November 9, 1984

Mr. Ralph Meyer
Fuel Behavior Branch
Office of Nuclear Regulatory Research
U.S. Nuclear Regulatory Commission
Washington, D.C. 20555

SOURCE TERM CODE PACKAGE SPECIFICATIONS

J. A. Gieseke, P. Cybulskis, M. R. Kuhlman
and K. W. Lee

FIGURE 1. EXPECTED STRUCTURE OF SOURCE TERM CODE PACKAGE

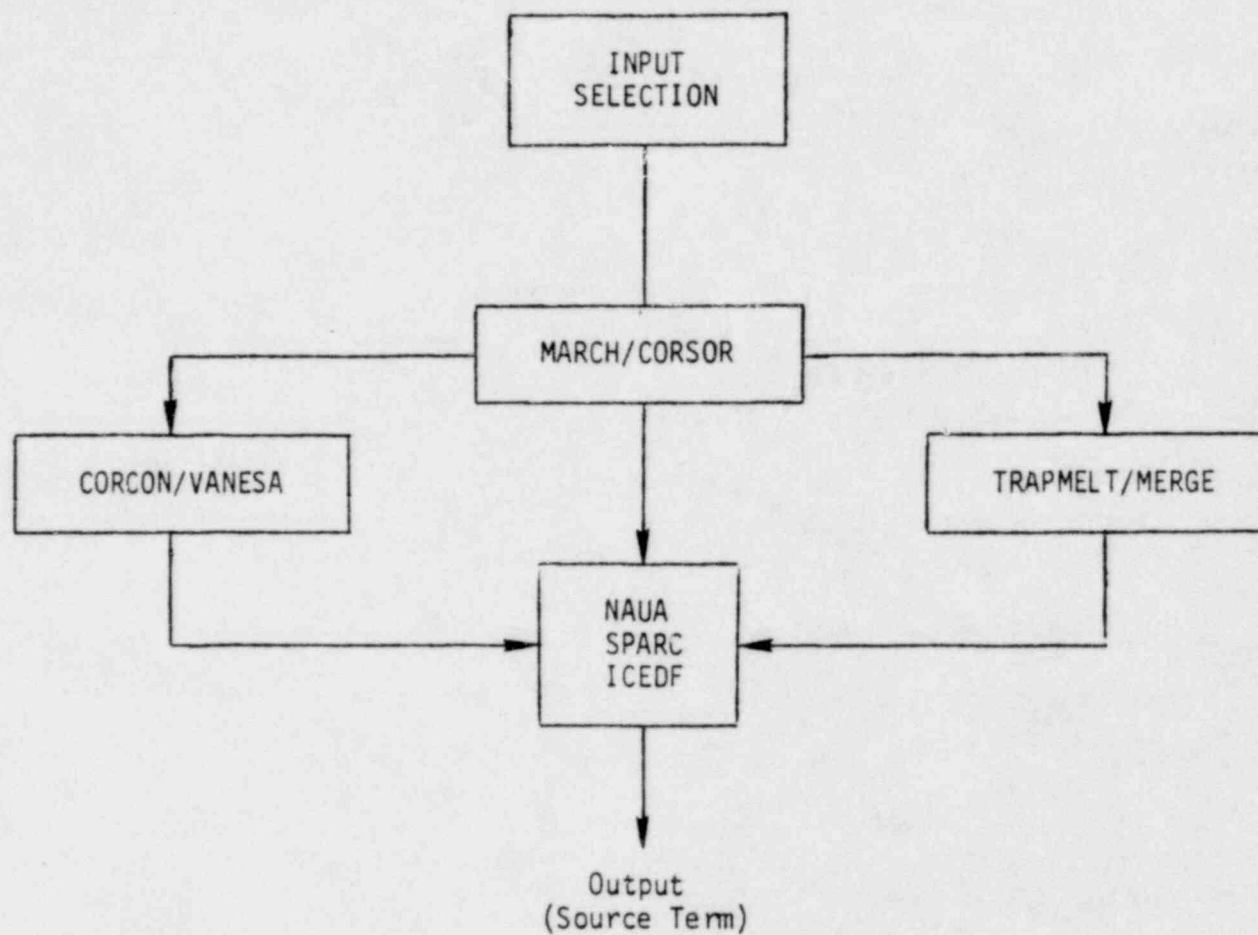
Can you put CORCON
into MARCH instead
of INTER?
